In re Patent No.: 6,798,641 B1

For: LOW COST, HIGH DENSITY  
DIFFUSION DIODE-CAPACITOR

**REQUEST FOR CERTIFICATE OF  
CORRECTION OF PATENT FOR PTO  
MISTAKE UNDER 37 C.F.R. §1.322(a)**

**FIG. 1**

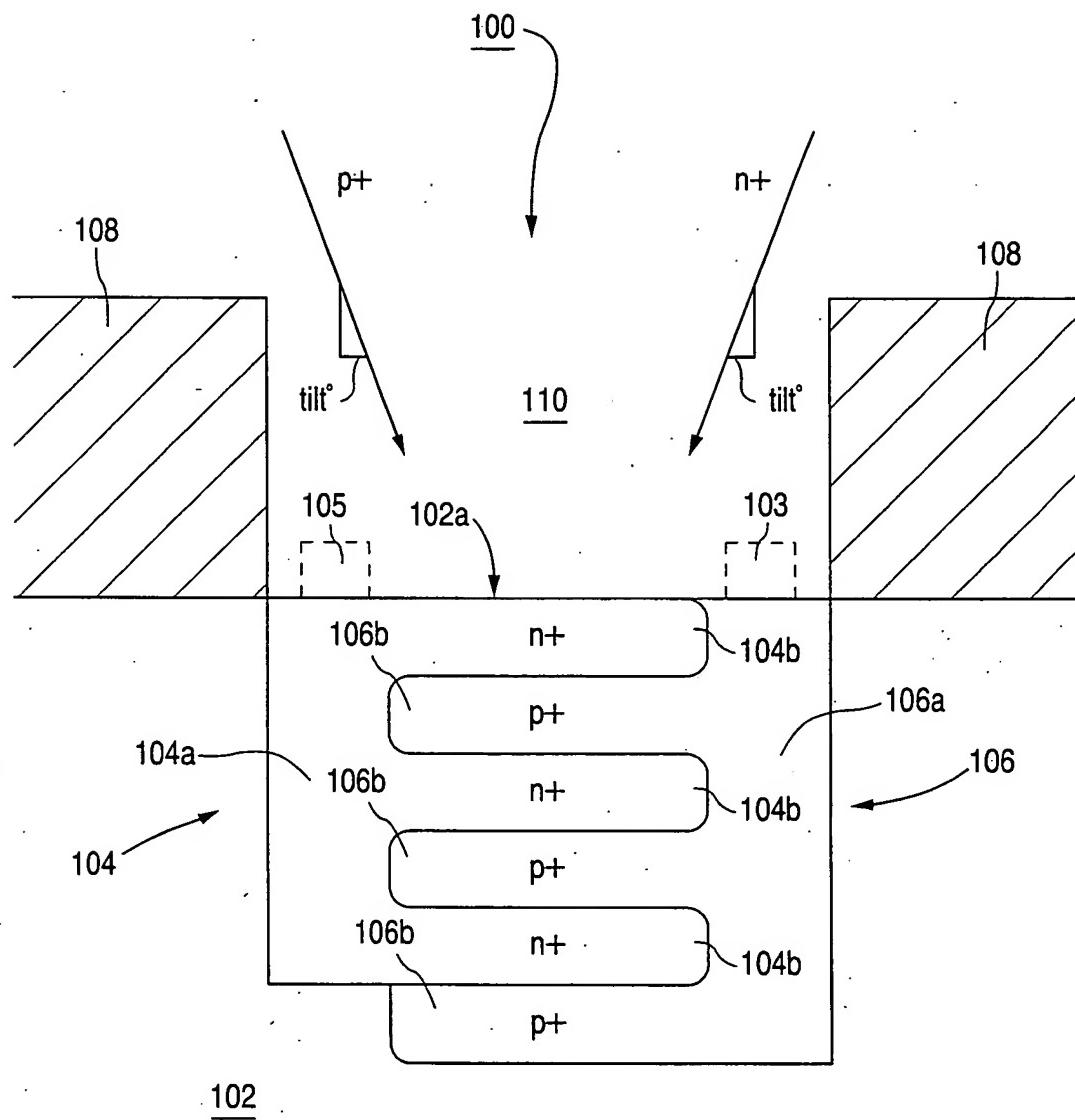
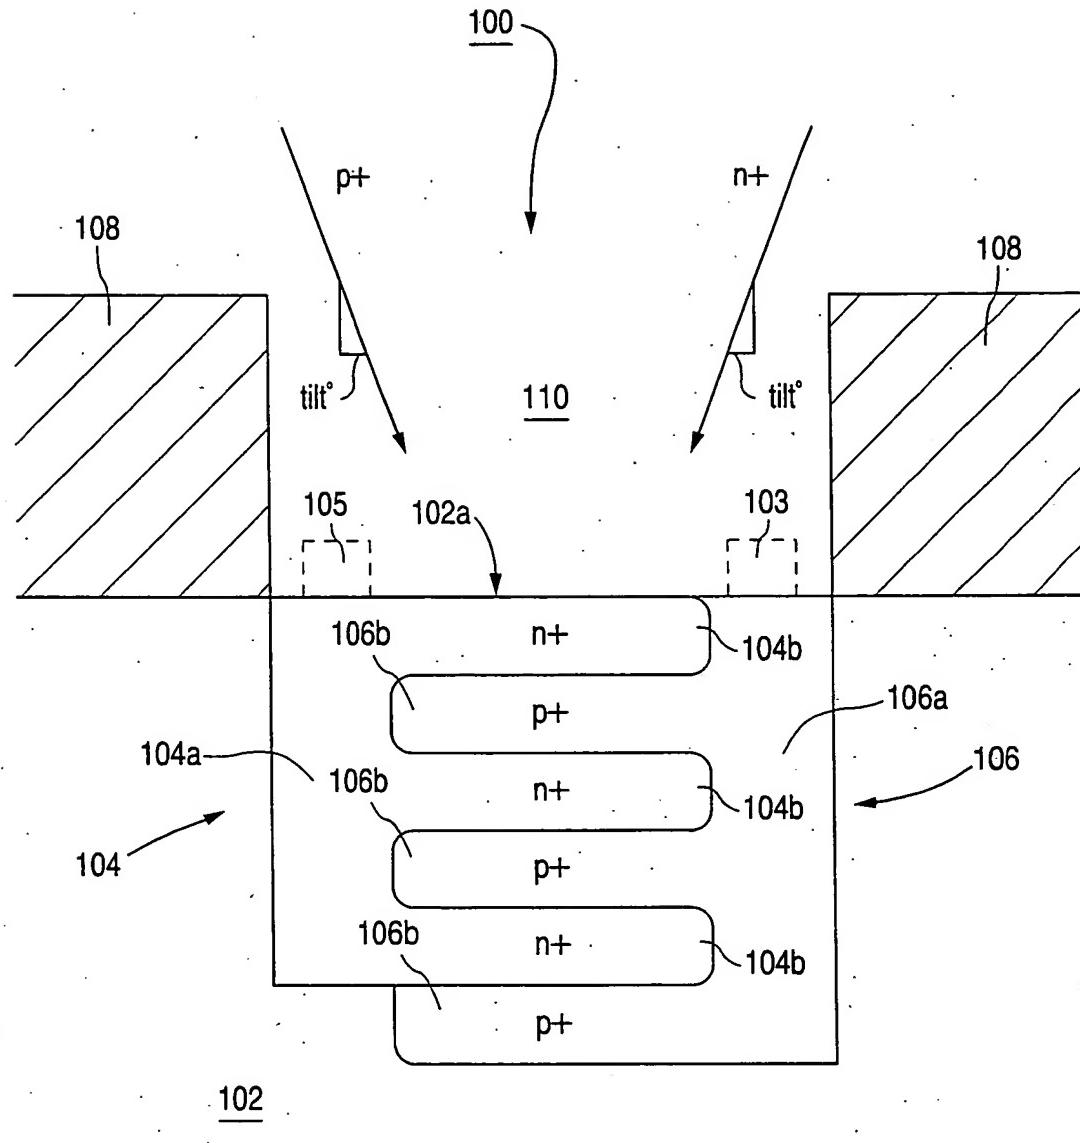
As evident from the above-stated paragraphs, Applicant timely filed formal drawings in the above-referenced application. Therefore, for the reasons listed above, Applicant respectfully requests a Certificate of Correction be issued in this application showing the formal drawings as filed in the PTO, and as attached hereto.

It is certified that error appears in the above-identified patent and that said Letters Patent is hereby corrected as shown below:

FIG. 1

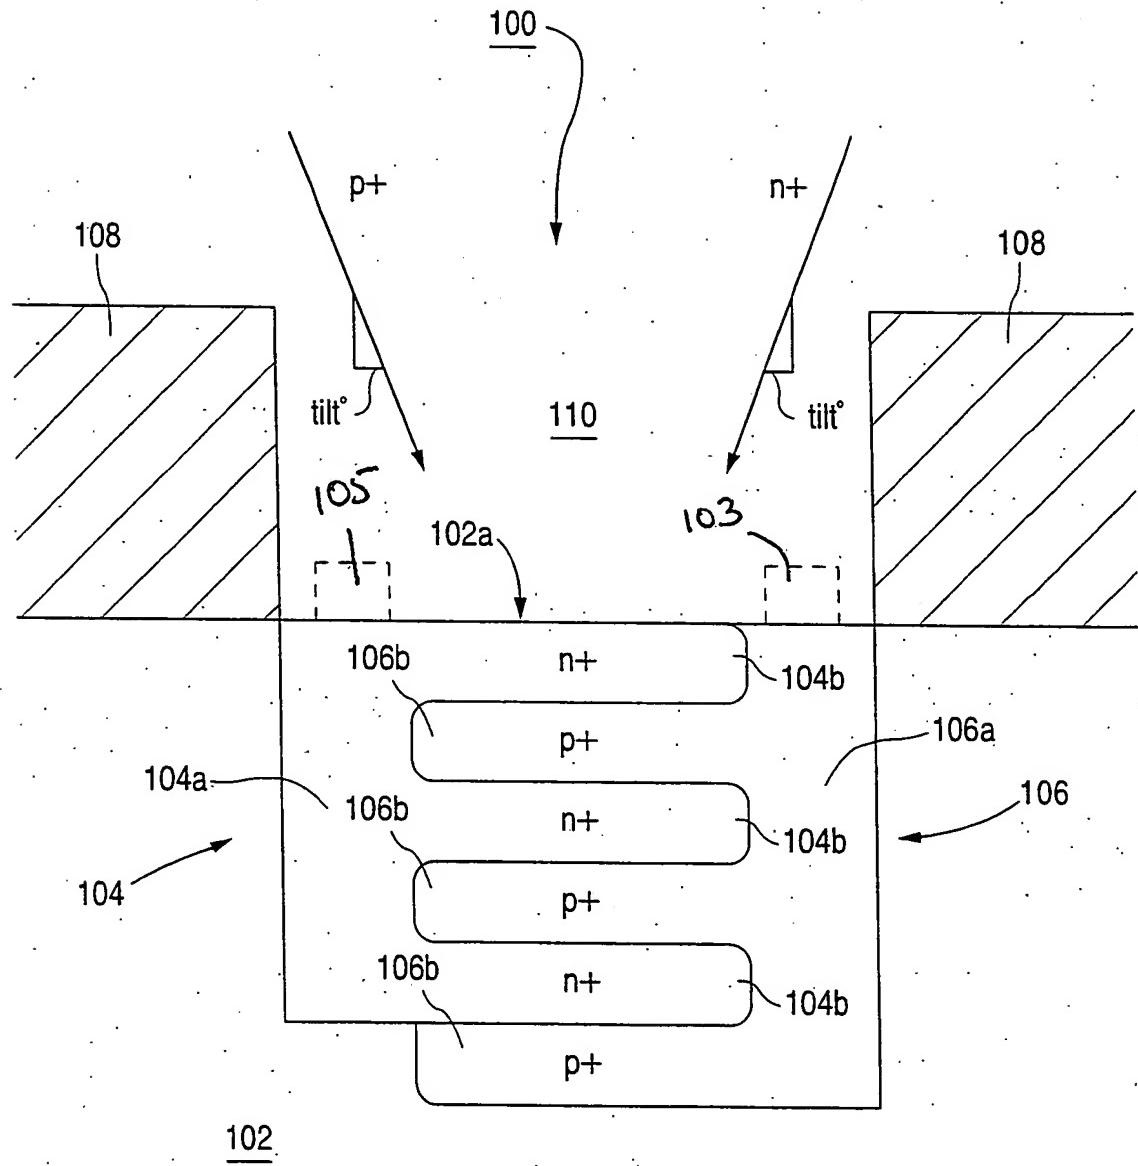
The Examiner objected to the drawings under 37 CFR 1.83(a), stating that the claimed "first conductive contact" and "second conductive contact" are not showing in the drawings.

Following the formation of the inter-digitated capacitor structure, a layer of aluminum or other conductive interconnect material is deposited over the capacitor structure and etched to provide a first conductive [contact] electrode 103 to the N-type dopant region 104 [(see Fig. 1)] and a second conductive [contact] electrode 105 to the P-type dopant region 106 [(see Fig. 1)]. The first conductive electrode 103 and the second conductive electrode 105 are shown in dashed lines in Fig. 1.

Attached hereto is a proposed amendment to Fig. 1 identifying a first conductive electrode 103 and a second conductive electrode 105, both of which appear in dashed lines in original Fig. 1. In addition, as indicated above, Applicant has amended the specification to more specifically recite the first conductive electrode 103 and the second conductive electrode 105.

**FIG. 1**

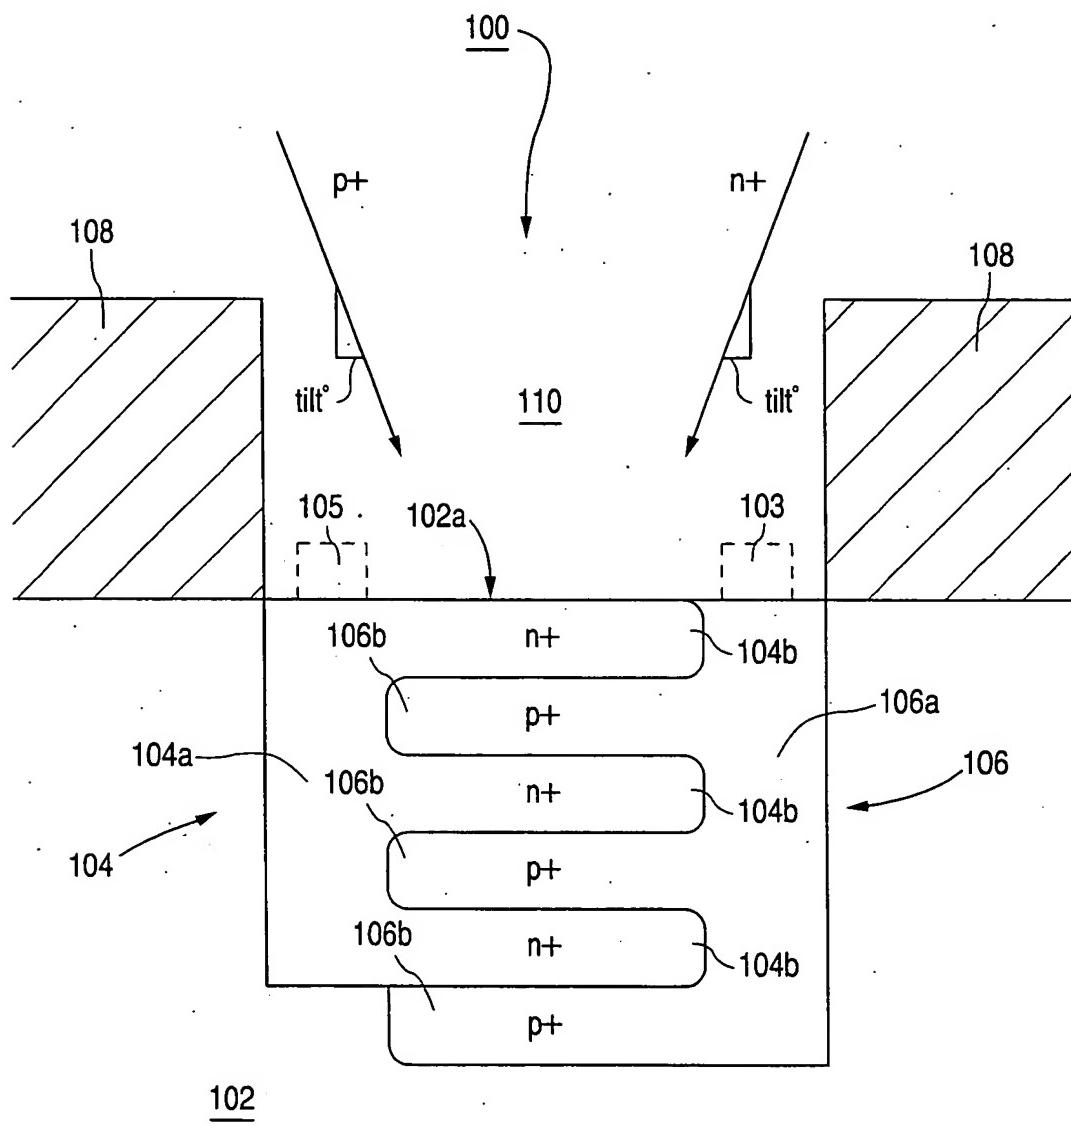
On March 1, 2004, the Examiner issued an Office Action in the application objecting to the drawings as failing to show every feature of the invention specified in the claims. The Examiner further stated: "A proposed drawing correction or corrected drawings are required in reply to the Office Action to avoid abandonment of the application. The objection to the drawings will not be held in abeyance."

To ensure that formal drawings are utilized in publication of the patent document for this application, Applicant submits a new sheet of formal drawings herewith that corresponds to the earlier filed formal drawings with proposed drawing correction included.
